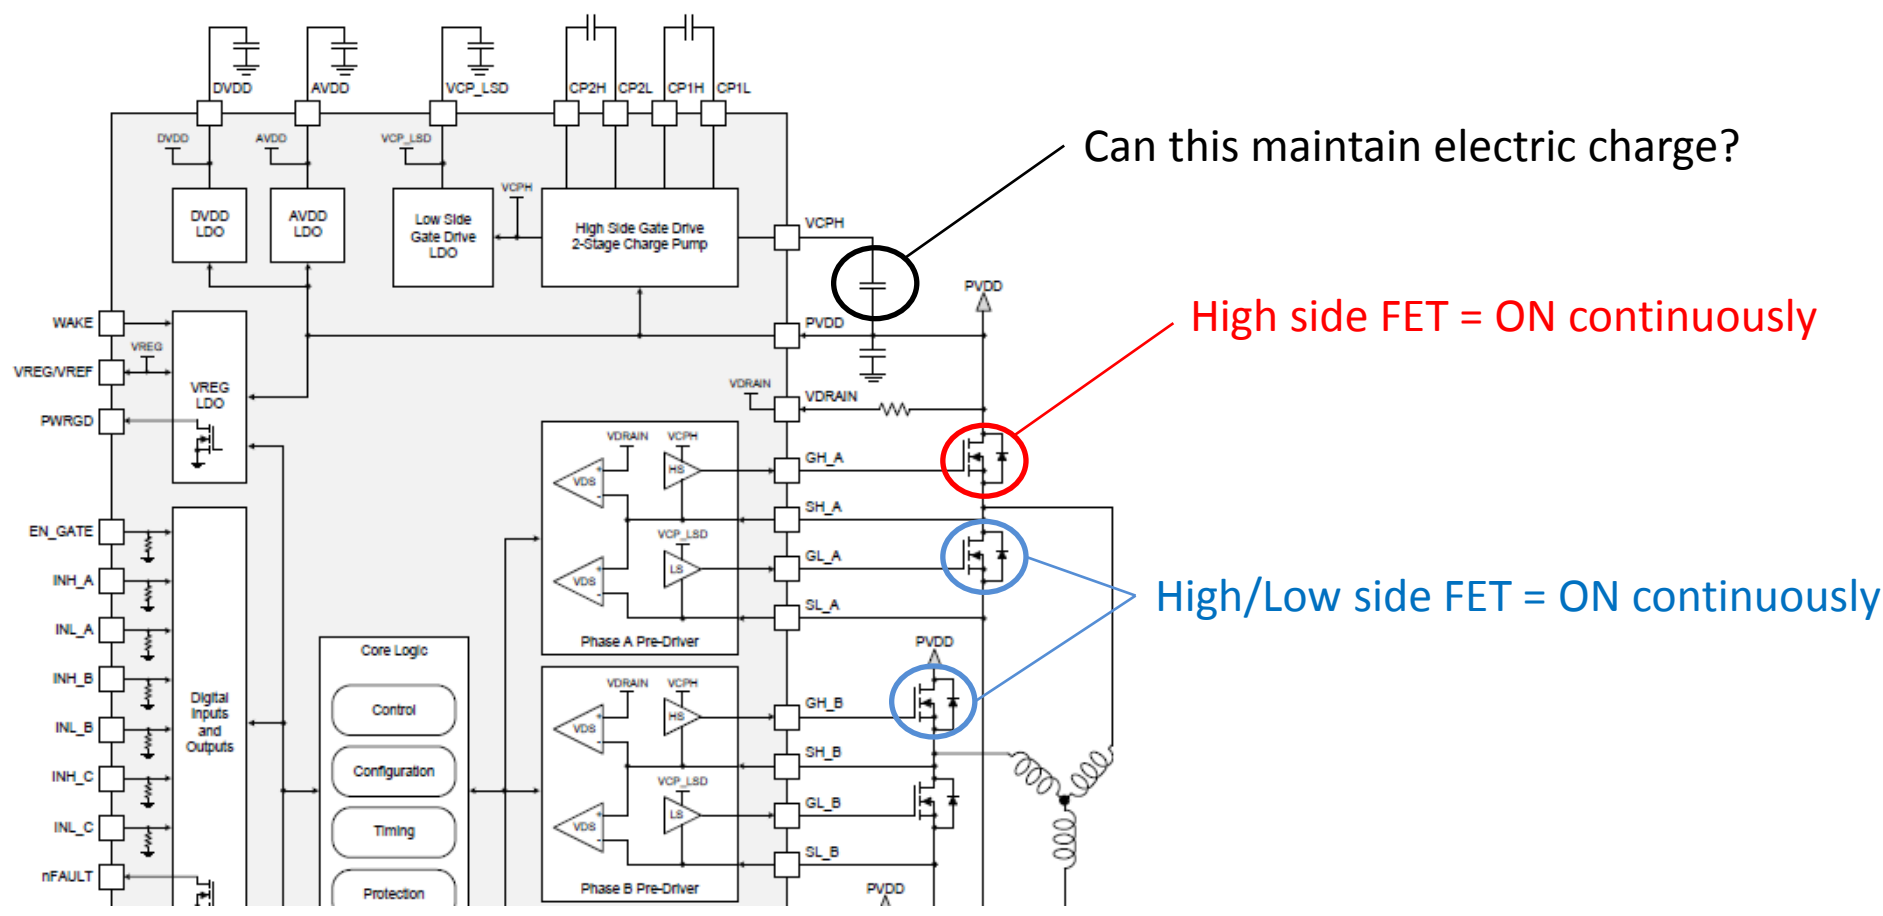
Question 1...VCPH-PVDD electric charge can maintain its capacitance under following situation?

the case that high side FET is ON continuously
and high/low side FET is ON continuously

Question 2...Does inrush current flow under following situation?
the case that electric charge of CP2H-CP2L and CP1H-CP1L are disappeared
and low side FET turn ON
